**KNOXVILLE/KNOX COUNTY METROPOLITAN PLANNING COMMISSION
SUBDIVISION REPORT - CONCEPT/USE ON REVIEW**

▶ **FILE #:** 4-SB-15-C **AGENDA ITEM #:** 10
4-C-15-UR **AGENDA DATE:** 6/11/2015

▶ **SUBDIVISION:** BEALS CREEK
▶ **APPLICANT/DEVELOPER:** ERIC MOSELEY
OWNER(S): Eric Moseley

**4-SB-15-C / 4-C-15-UR
CONCEPT PLAN/USE ON REVIEW**

CONCEPT
 GRADING AND
 DRAINAGE PLAN

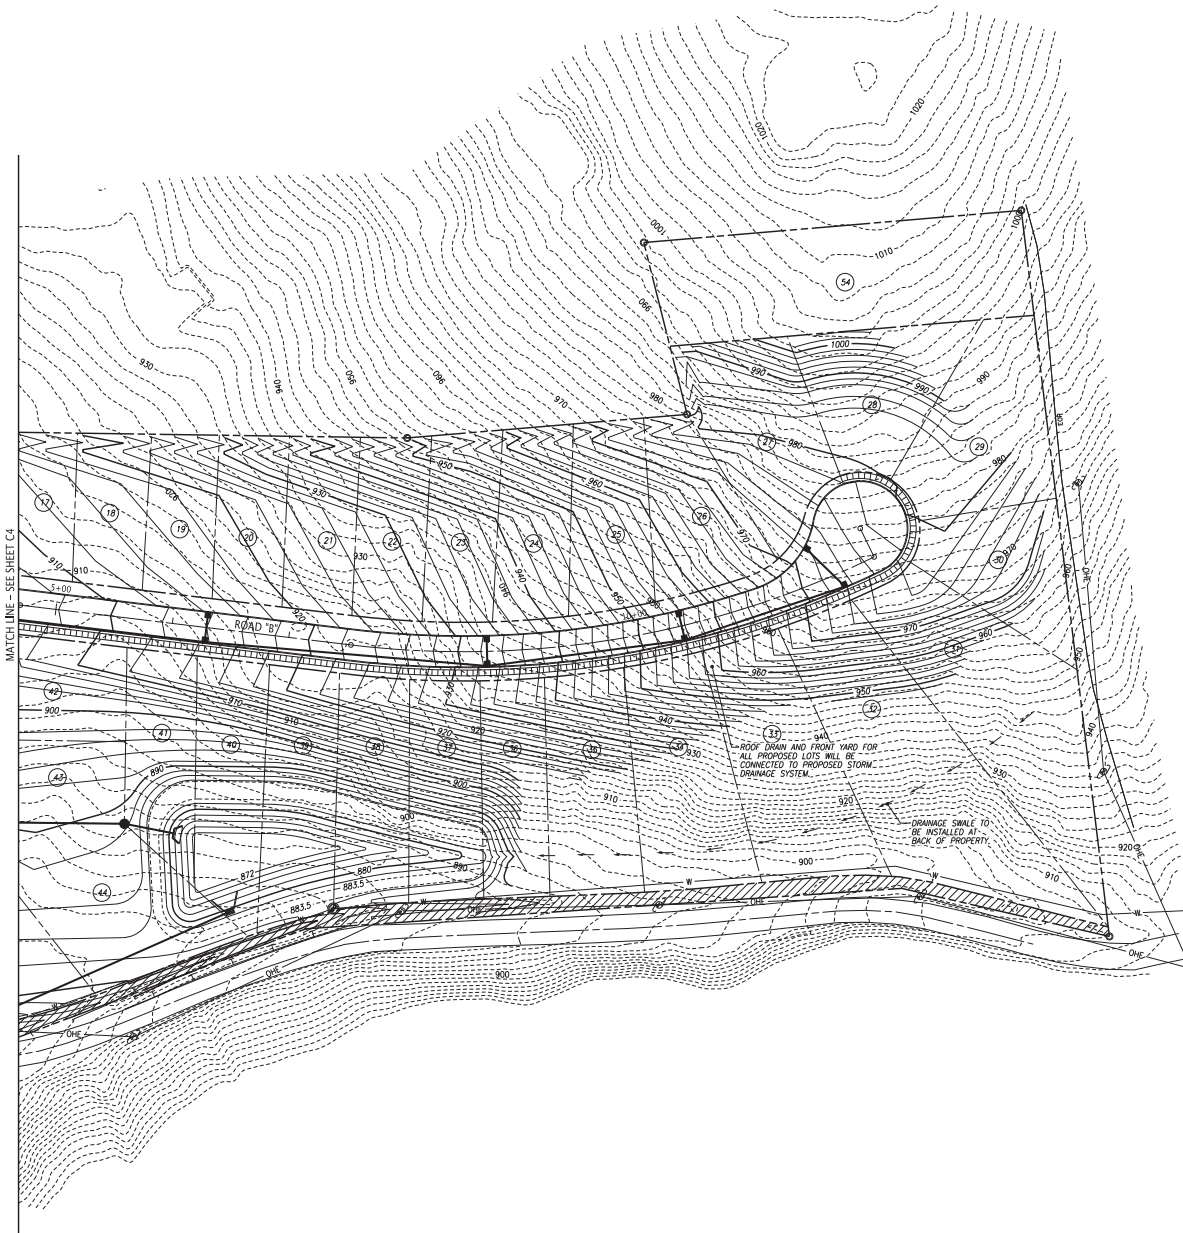
Based on the developer's site plan, there is the inevitability of needing to clear cut and grade a 7.61-acre portion of this property that has slopes at or greater than 15% which are technically protected by the Knox County Hillside and Ridgetop Protection Plan. This plan provides for the protection of 50-80% of these steep slopes in a PR development. The developer's subdivision plan does not provide this protection.

The developer intends to clear cut and grade the steep hillsides on the southern half of the property in disregard of the Hillside and Ridgetop Protection Area guidelines.

Half of this property is within the Slope Protection Area. The 10 acres on the south end are part of the ridge that extends through the area. The 10 acres on the north end are part of the valley that borders the stream. The plan destroys the steep slopes on the south end of the property.

The part of the property where the proposed variance to a 15% grade is located is within the Hillside and Ridgetop Protection Area. The grading plan provided by the developer shows that nearly the entire hillside area will be clear-cut and graded. The Hillside and Ridgetop Protection Plan allows only 20%-50% of the land to be disturbed in PR developments in Hillside and Ridgetop Protection Areas. See HRPP Table 3, p.33. The developer here makes no effort to protect the steep ridge. The Minimum Subdivision Regulations preclude his plan to use a local street with a 15% grade.

The developer has provided calculations which purport to show the drainage plan can meet current stormwater regulations, but there are problems which should be remedied. The proposed plan has two retention ponds which are designed not to drain completely and which will retain water all year. Two stagnant ponds providing habitat for mosquitoes will result in many neighborhood complaints, and may make it more likely for residents to illegally alter the ponds so that the water drains from them.

Also the proposed drainage plan will detain water on site from only part of the developed area not the entire property. While the stormwater model for this site may pass the math test, it is not acceptable result. MPC and Knox County Engineering should require an improved drainage system to assure that the water is adequately detained on site and does not damage Mourfield Road or downstream properties.

CONCEPT ROAD PROFILES

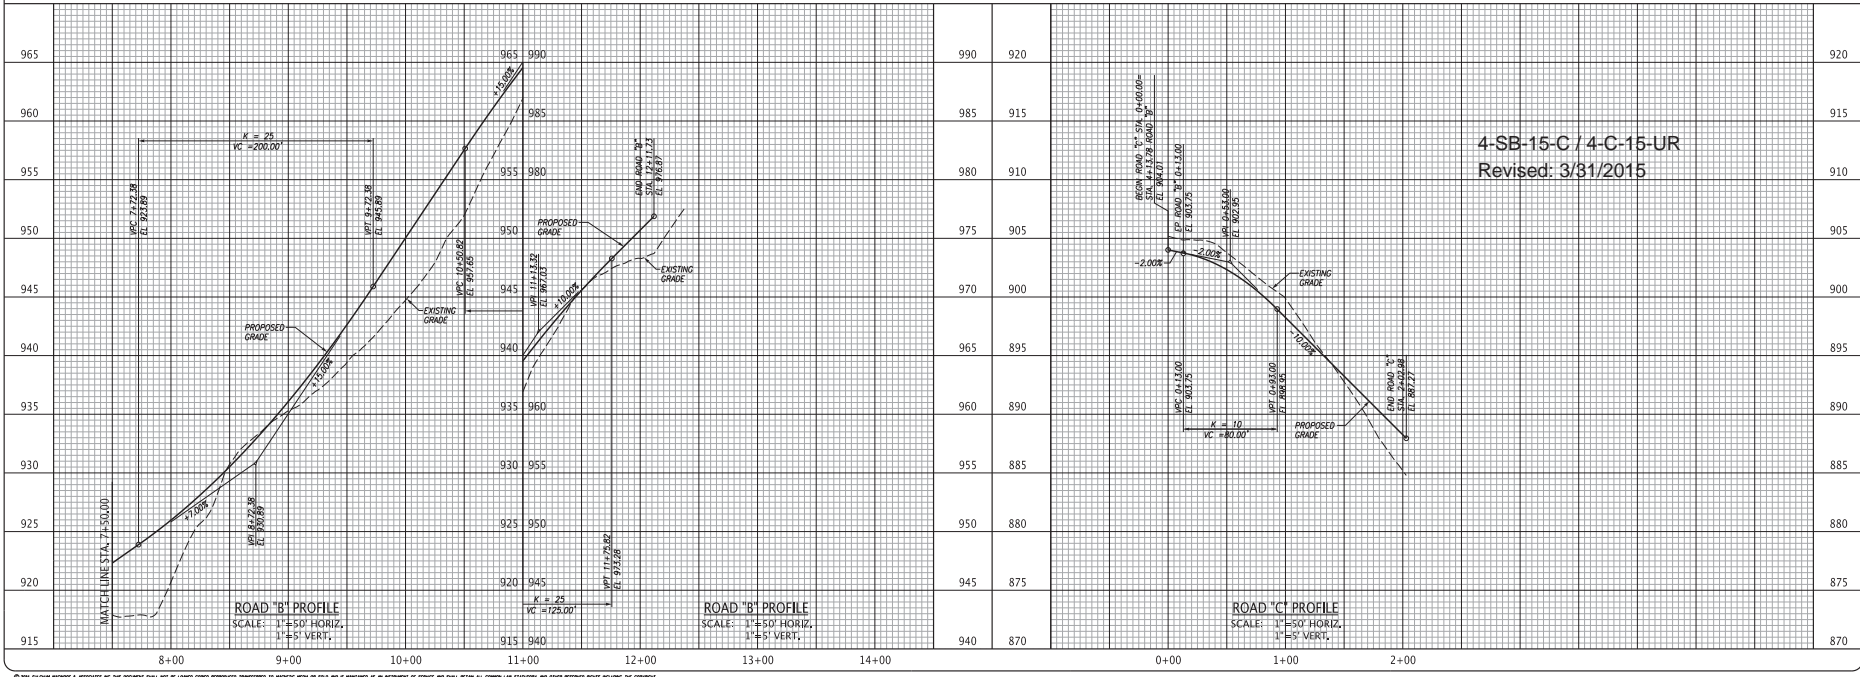
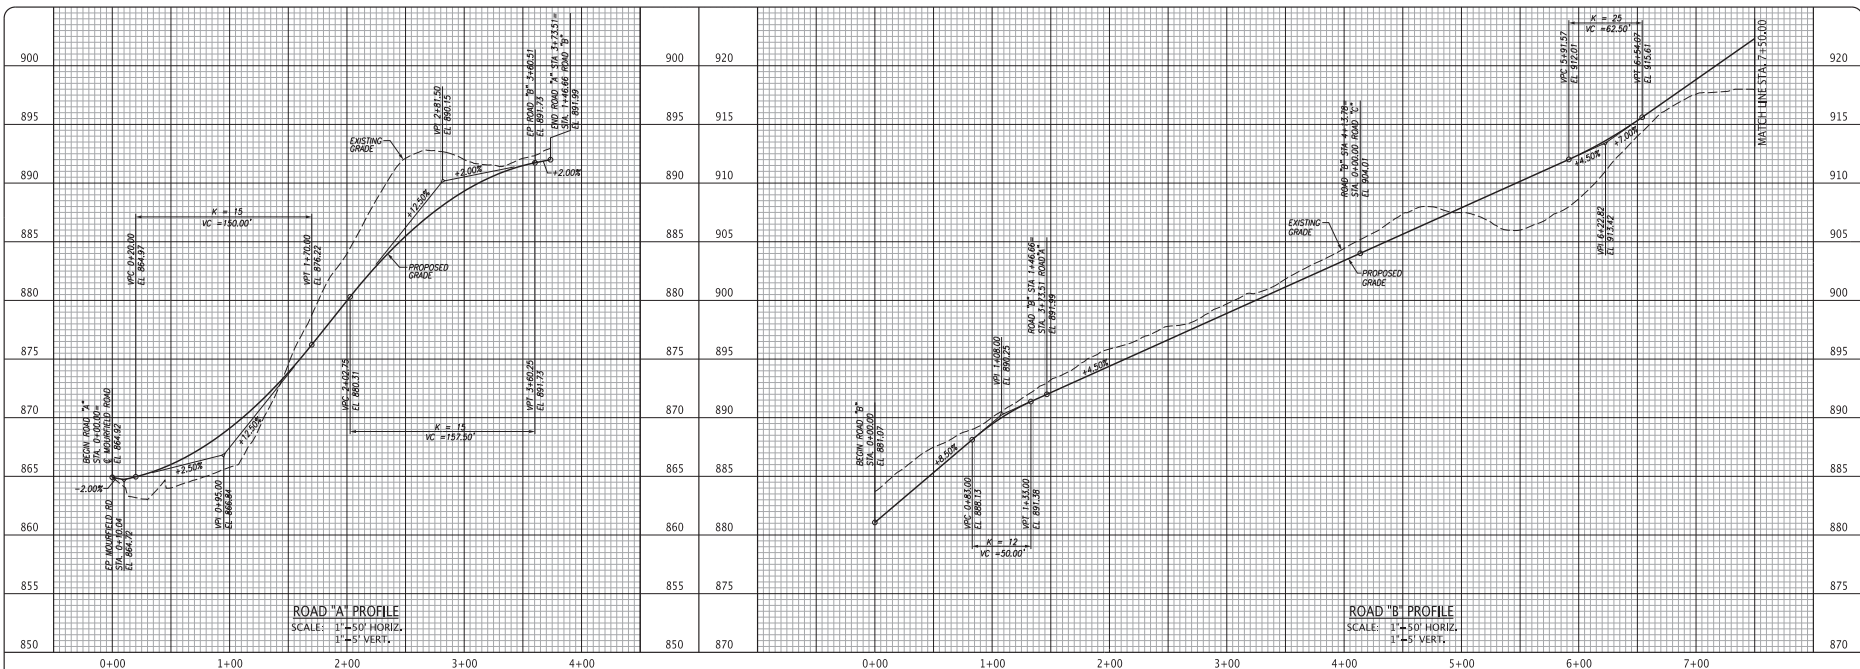
The Minimum Subdivision Regulations (MSR 62-60) provide that local street maximum grade is 12%. The developer has requested a variance for Road "B" of a grade of 15%. The staff recommendation contains no discussion other than the statement that the site's topography restricts compliance with the subdivision regulations and the proposed variances will not create a traffic hazard. No valid reasons have been provided to support variances to the road in the protected slope area.

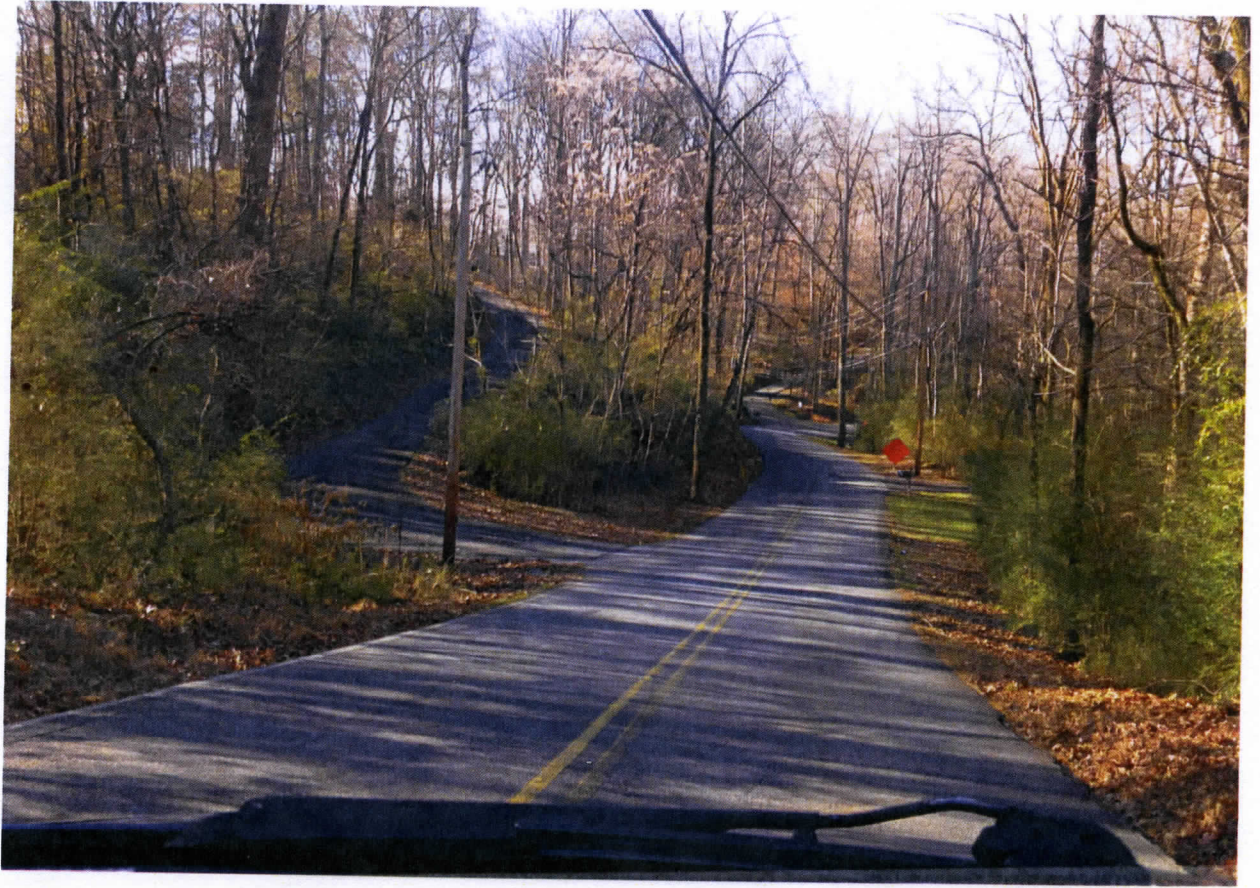
See attached pictures of the mature trees in the center of the property, looking north and south from the current driveway of the property on Mourfield Road, and driving south to north on Mourfield Road toward Westland Drive.
